RENESAS TECHNICAL UPDATE

Product classification	MPU & MCU	Document No.	TN-V85-A028A/E	Rev.	1.00
Title	Document Modification of Standard Self Programming Flow		Notification classification	Technical Information	
Affected Products	In the main part	Affected production lot	Related documents	User's Manual : Hardware of affected products	
		All lots

Standard Self Programming Flow

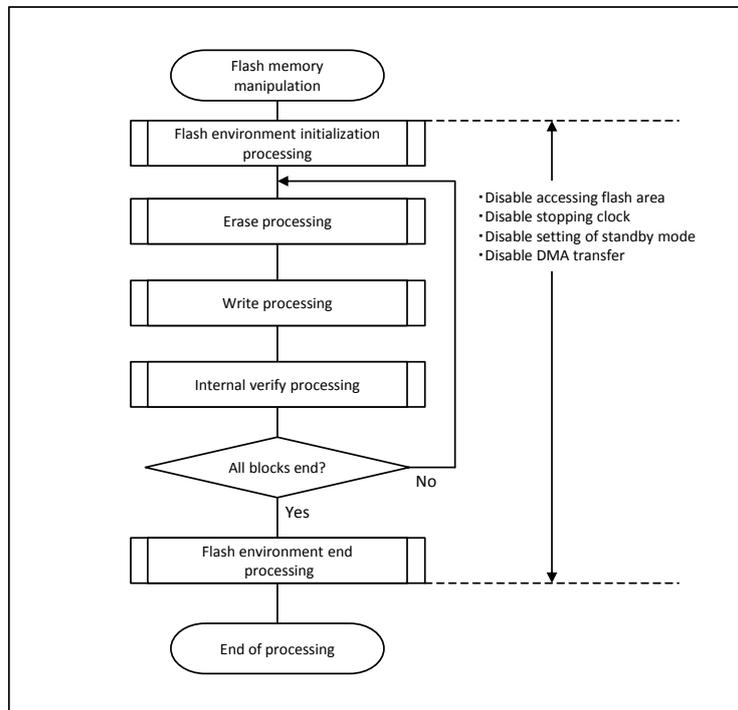
We correct from "Disable setting of standby mode other than the HALT mode" to "Disable setting of standby mode".
